# UNITED STATES PATENT AND TRADEMARK OFFICE

APPLICATION NO.	F	ILING DATE	FIRST NAMED INVENTOR	ATTORNEY DOCKET NO.	CONFIRMATION NO.
10/814,652 04/01/2004		04/01/2004	Hirobumi Shirataki	XA-10075	5968
181	7590	07/27/2005		EXAMINER	
MILES &	STOCKE	BRIDGE PC	RODRIGUEZ, SAUL		
1751 PINN.	ACLE DR	IVE		LDT LDUT	DARED MUADED
SUITE 500			ART UNIT	PAPER NUMBER	
MCLEAN, VA 22102-3833				3681	
				DATE MAILED: 07/27/2005

#### **DETAILED ACTION**

This is a first office action on the merits of patent application S. N. 10/814,652.

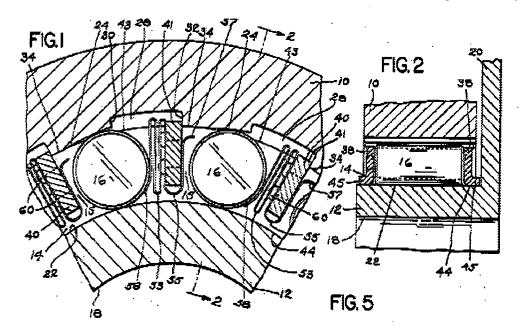
Claims 1-10, as understood, are rejected under 35 U.S.C. 102(b) as being anticipated by Sauzedde et al. ('053).

Sauzedde et al. discloses a one-way apparatus comprising outer and inner races (10, 12), cam surfaces (24), a cylindrical surface (22), torque transmission members (16), biasing means or accordion springs (53), block bearing members (45), a rotatable retainer (14), a retaining groove (28), a latch piece (24), and a retaining column (40).
